Public works DEPARTMENT.

*Proceedings of the Madras Government, Public Works Department,
21st April 1871.*

In reference to G. O., No. 2,753, of the 16th November last, calling for a report on the ovens of the Government Bakery at Bangalore, I have the honour,

Section

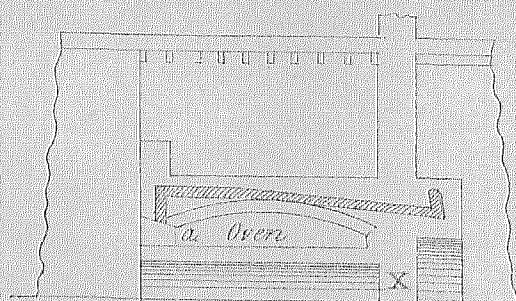
3. The absence of dampers is, however, a serious drawback to the economical working of the ovens. For want of these, the mouth of the smoke-flues of each oven is entirely outside the oven door, and necessarily so, as otherwise, *i.e.*, were the mouth of the flue to be inside the oven, when the door was shut the heat would escape up the flue. The result now is that, as there is no means of regulating the draught, there is an extravagant consumption of fuel with a great waste of heat-power.

dust in the air when the ovens are raked out just before the loaves are put in, and the dough absorbs a quantity of deleterious particles detrimental to the health of the troops. This can be obviated by making an opening through the backing-walls of the arches on which the ovens rest, at the point marked X on the sketch, and running the ash-boxes, either on wheels or skids, through these openings to the back of the building.

4. It would appear, therefore, that Mr. Greatorex's suggestions regarding the damper and door could not be adopted in this oven, for if air for combustion be not admitted by the door it would have to descend by the flue; in this case it is not very apparent how the smoke could escape by the flue.

Section.

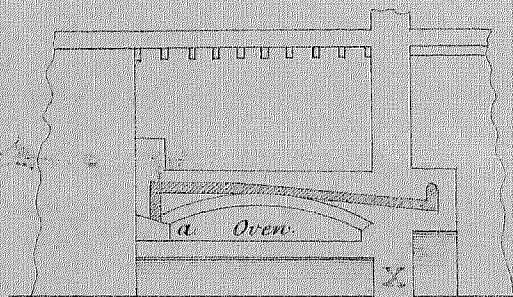
It would appear, therefore, that Mr. Greville's suggestions regarding the damper and door could not be adopted in this oven, for if air for combustion be not admitted by the door it would have to descend by the flue: in this case it is not very apparent how the smoke could escape by the flue.

Loaves are put in, and the dough absorbs
a quantity of deleterious particles detri-
mental to the health of the Troops. This
can be obviated by making an opening
through the backing walls of the arches
on which the ovens rest, at the point marked
X on the Sketch, and running the ash-holes,
either on wheels, or skids, through these
openings to the back of the building.
